**NORTH OAKVILLE SUBWATERSHED
MANAGEMENT STRATEGY
(WITHOUT PREJUDICE)**

Mediation Item: Hydrology model and hydraulic model for a portion of Joshua's Creek floodplain mapping (May 31, 2007)

Mediation Item: Regional Storm Flood Protection (May 30, 2007)

Figure B - SWM Pond Locations
 June 19, 2007
 Without Prejudice

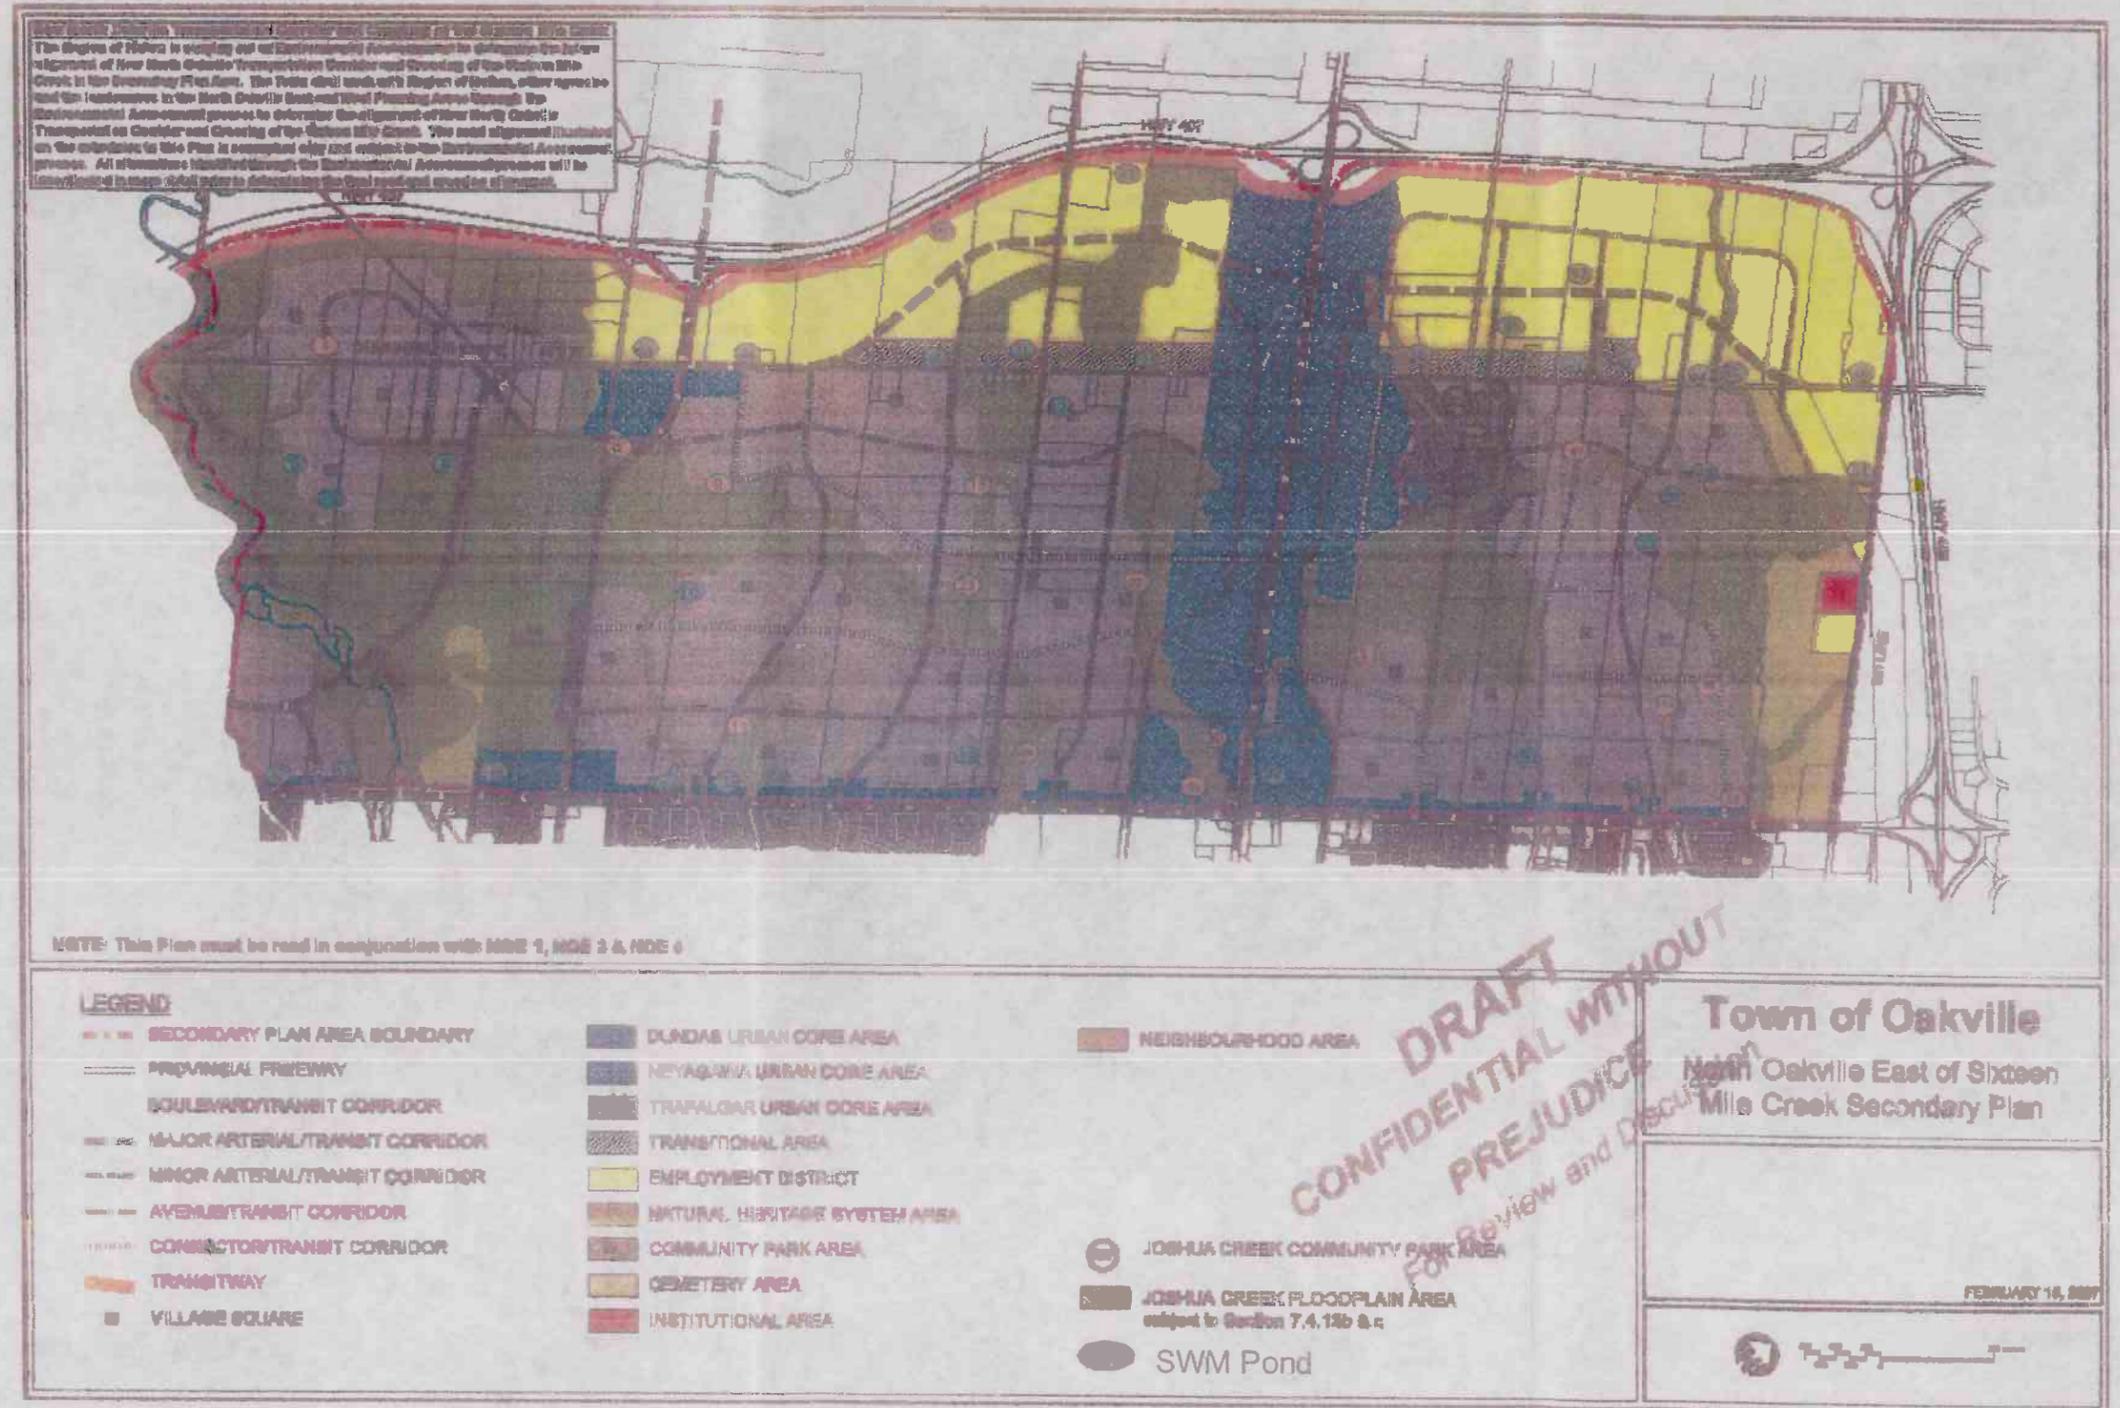
- d) Figure B reflects the agreed upon and not agreed upon conceptual SWM pond locations. Table A presents the status of all SWM ponds (i.e., agreements on ponds that can be removed, ponds that are needed, ponds not agreed upon and pond not discussed).

- e) It is noted, and agreed upon, that the plan^{is} (Figure B) ~~are~~ conceptual, illustrating the general number of ponds and their location. During the Environmental Implementation Report (EIR) phase, the number, location and size of SWM ponds will be finalized.

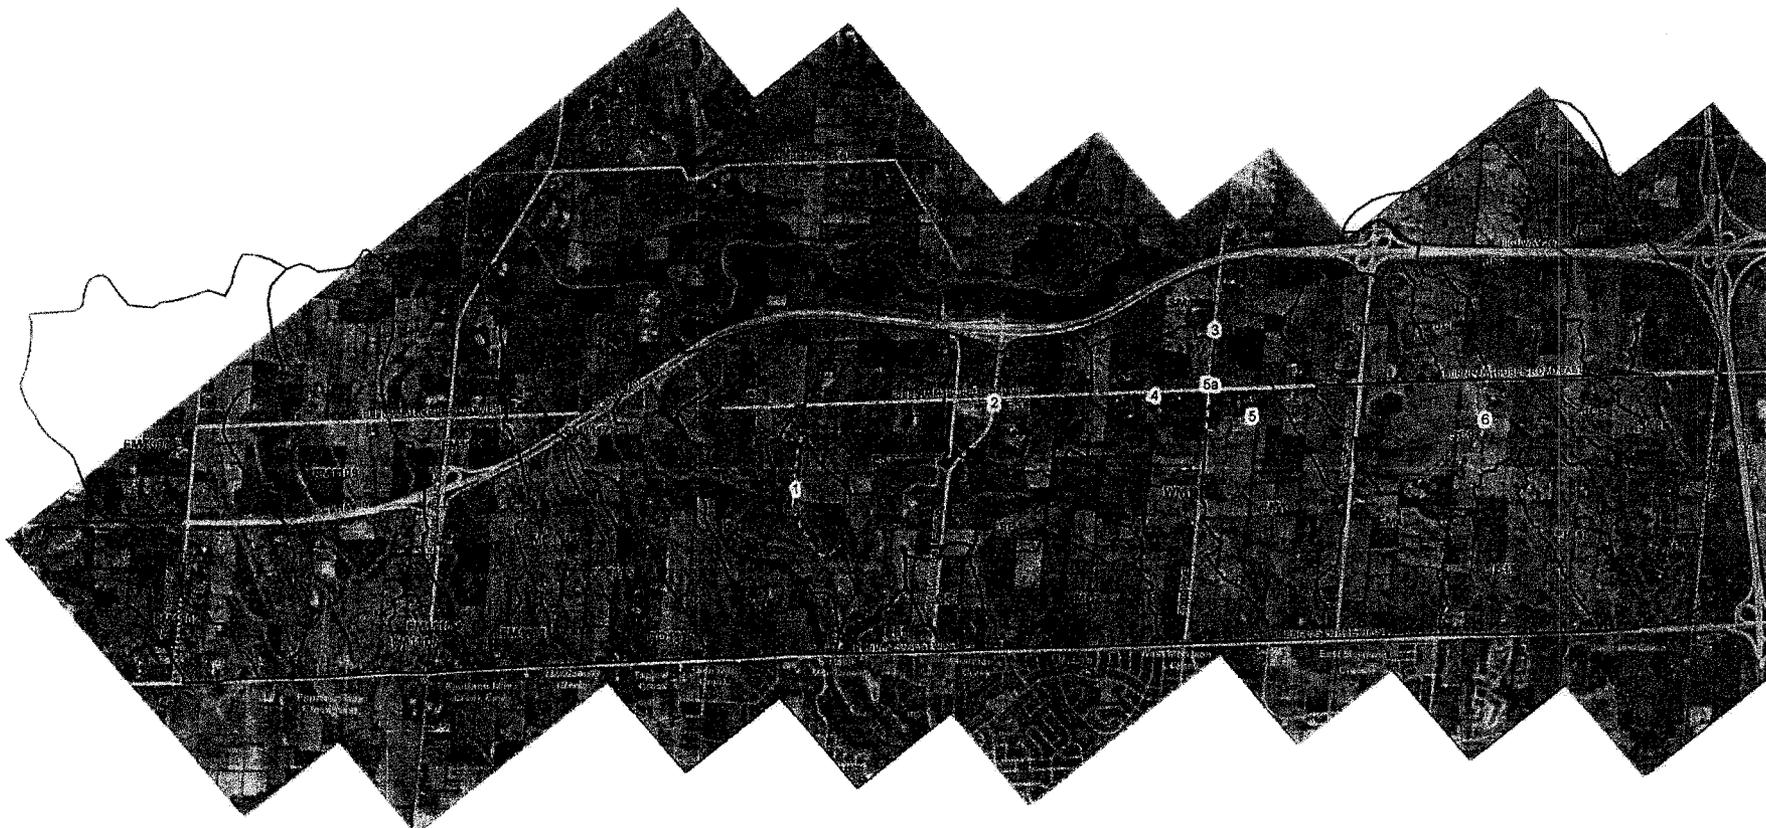
With respect to the boundaries numbered on the attached copy of Appendix 7.2:

- a) Line 1 will be added;
- b) Line 2 will be added;
- c) Line 3 will be added with a footnote as follows: This EIR boundary separates EIR and FSS studies east and west of Sixth Line. The issue shared by both areas is the outlet of drainage from lands east of Sixth Line through lands west of Sixth Line and pond locations. Separate EIR/FSS studies may be completed for each subcatchment as long as whichever EIR/FSS proceeds first prepares a scoped drainage and stormwater management plan addressing drainage area boundaries, outlet elevation, outlet location and potential grading implications of outlet conditions as well as SWM control needs for both areas (conceptually only in area not proceeding first; FSS level of detail on area proceeding first).

- d) Line 4 will be added with a footnote as follows: This EIR boundary separates EIR and FSS studies north and south of Burnhamthorpe Road. The issue shared by both areas is the outlet of drainage from lands north of Burnhamthorpe Road through lands south of Burnhamthorpe Road and pond locations. Separate EIR/FSS studies may be completed for each subcatchment as long as whichever EIR/FSS proceeds first prepares a scoped drainage and stormwater management plan addressing drainage area boundaries, outlet elevation, outlet location and potential grading implications of outlet conditions (i.e., potential stream relocation/lowering including consideration of possible alternative conditions relating to minimum interim requirements versus ultimate final conditions) as well as SWM control needs for both areas (conceptually only in area not proceeding first; FSS level of detail in area proceeding first).

- e) Line 5 will be added; line 5a will be removed;
- f) A modified line 6, as shown on Appendix 7.2, will be added with a footnote as follows: This EIR boundary separates EIR and FSS studies on either side of the Joshua's Creek. The EIR/FSS that proceeds first, (on either side of this line), is to prepare a scoped drainage and stormwater management plan addressing drainage area boundaries, outlet elevation, outlet location, potential grading implications of outlet conditions, potential stream relocation/lowering including consideration of possible alternative conditions (i.e., minimum interim requirements versus ultimate final conditions) and SWM control needs for both subcatchments (conceptually only in area not proceeding first; FSS level of detail in area proceeding first), as well as the potential new linkage east of Joshua's Creek and potential stream relocation into this linkage. As part of the assessment of
